MARK-up for
Dcr181

THERMISTORS

ESCC Detail Specification No. 4006/014

DCR No.	CHANGE DESCRIPTION
118 181	Specification upissued to incorporate editorial and technical changes per DCR.

FIGURE 2 - PHYSICAL DIMENSIONS

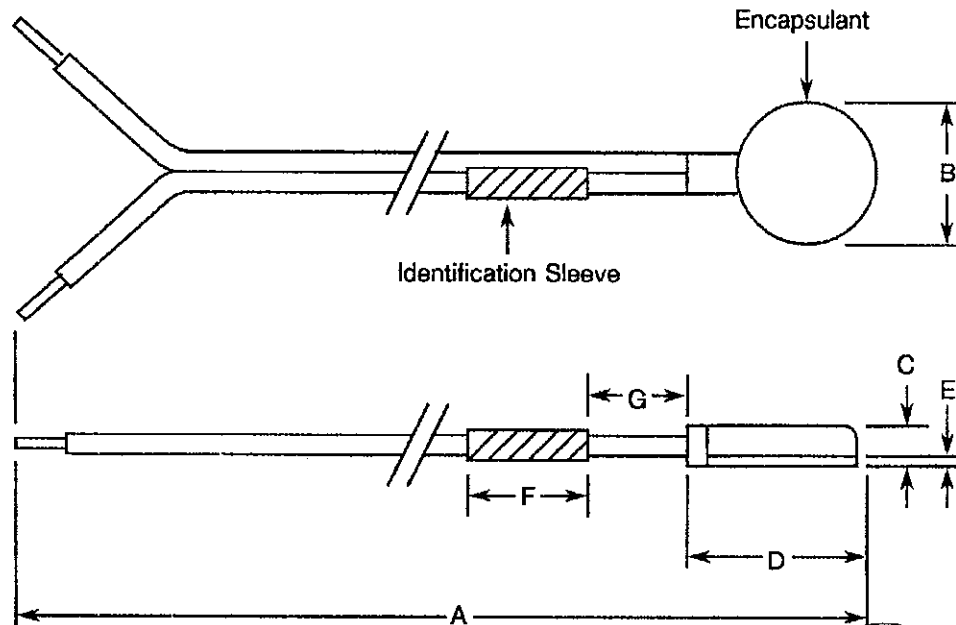
SYMBOL	MILLIMETRES			
	VARIANTS 01-05		VARIANTS 06-07	
	MIN.	MAX.	MIN.	MAX.
A	280.00	330.00	356.00	406.00
B	6.10	6.60	6.10	6.60
C	-	2.80	-	2.40
D	-	9.80	-	9.80
E	0.33	0.48	0.33	0.48
F	-	50.00	-	50.00
G	50.00	80.00	50.00	80.00
